**PCN#20201117000.1
New Tray for Select Devices
Final Change Notification**

PCN Number:	20201117000.1	PCN Date:	Dec. 11, 2020
Title:	New Tray for Select Devices		
Customer Contact:	PCN Manager	Dept:	Quality Services
Proposed 1st Ship Date:	Mar. 11, 2021		
Change Type:			
<input type="checkbox"/>	Assembly Site	<input type="checkbox"/>	Design
<input type="checkbox"/>	Assembly Process	<input type="checkbox"/>	Data Sheet
<input type="checkbox"/>	Assembly Materials	<input type="checkbox"/>	Part number change
<input type="checkbox"/>	Mechanical Specification	<input type="checkbox"/>	Test Site
<input checked="" type="checkbox"/>	Packing/Shipping/Labeling	<input type="checkbox"/>	Test Process
		<input type="checkbox"/>	Wafer Bump Site
		<input type="checkbox"/>	Wafer Bump Material
		<input type="checkbox"/>	Wafer Bump Process
		<input type="checkbox"/>	Wafer Fab Site
		<input type="checkbox"/>	Wafer Fab Materials
		<input type="checkbox"/>	Wafer Fab Process

Description of Change/Change Proposal: 20x20x1.4 LQFP

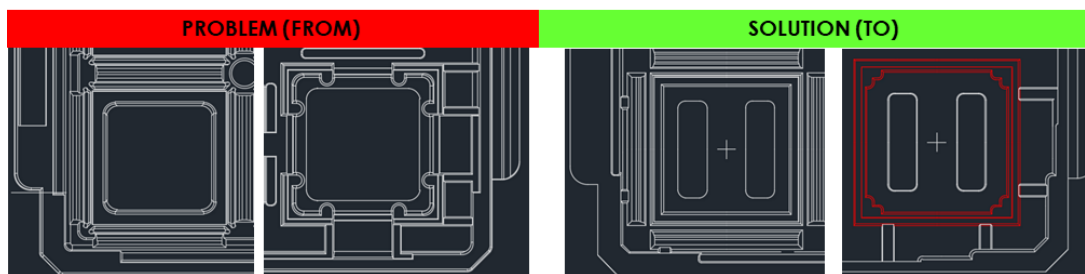
Texas Instruments is pleased to announce the qualification of a new tray for the devices listed below. A comparison summary of the tray differences as follows:

4221582-0001	4225805-0001
Supplier	UBOT	Peak
Floor design	Square circular edge	Square with 2 oblong
Cavity size	22.30 +/- 0.1 (Top) 20.60 +/- 0.1 (Bottom)	22.25 +/- 0.08 (Top) 20.40 +/- 0.1 (Bottom)
Seating ht	2.00 +/- 0.1 (Top) 0.77 +/- 0.1 (Bottom)	1.70 +/- 0.1 (Top) 1.10 +/- 0.1 (Bottom)

New tray offers improvement on tray warpage, chipping, stuck up caused by current tray
